**ZONING AMENDMENT &  
SUBDIVISION STAFF REPORT****Date: August 20, 2015****APPLICANT NAME**

Board of Water and Sewer Commissioners of the City of Mobile

Dumas Subdivision, Resubdivision of and Addition to Lot 1

**LOCATION**1060 Spring Hill Avenue and 160 North Pine Street  
(Northeast corner of Spring Hill Avenue and North Pine Street)**CITY COUNCIL  
DISTRICT**

# PROPOSED SITE PLAN

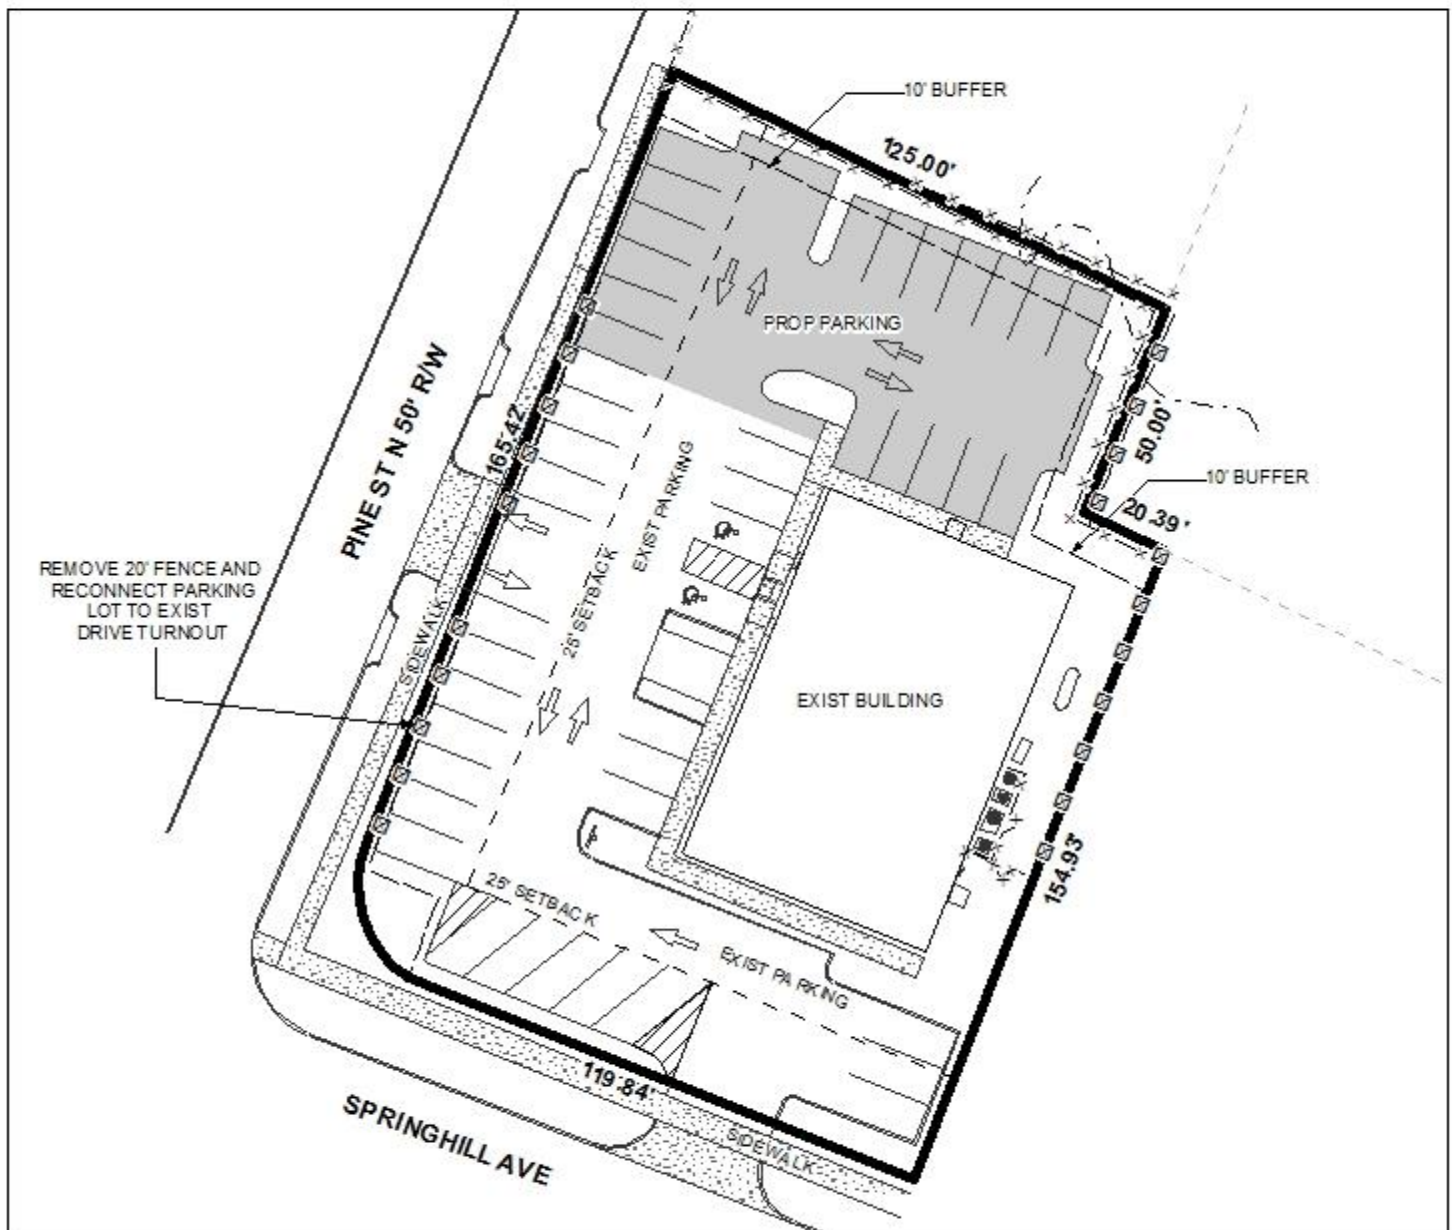
In reference to tree and landscaping compliance, the existing landscaping appears compliant. The site plan also depicts a proposed 10' wide buffer strip, in addition to a 6' high wooden privacy where the site abuts residentially used property. The applicant should be aware that any proposed privacy fence should not exceed a height of 3' within any required front yard setback. As the applicant does not propose any structural expansions at this time, full compliance with the tree and landscaping requirements of the Zoning Ordinance will not be required until the time of development if the total gross floor area of the site is increased and/or decreased by at least 50% of the existing building's footprint. The new parking lot, however, should be built to full tree and landscaping compliance.

In regards to parking, the existing 5,445 sf. building requires a total of 19 parking spaces. Although the site currently has approximately 32 spaces, which exceeds the minimum requirements, the applicant is proposing to reconfigure the existing parking layout in order to improve onsite traffic circulation. 19 new parking spaces are also illustrated on the site plan to

comfortably accommodate the anticipated customers and employees. It should be pointed out that as proposed, a total of 45 parking spaces are planned; however, only 3 spaces contain curbing. As such, the revised site plan should illustrate curbing or wheel stops for all parking facilities. In addition, Staff recommends the elimination of the 3 parking spaces adjacent to the southeastern corner of the building.

It should be pointed out that there is no dumpster depicted on the site plan, which would suggest waste removal will be via curb-side pick-up. As such, any revised site plan should illustrate the location of a dumpster in compliance with Section 64-4.D.9. of the Zoning Ordinance, or a note stating that waste removal will be via curb-side pick-up.
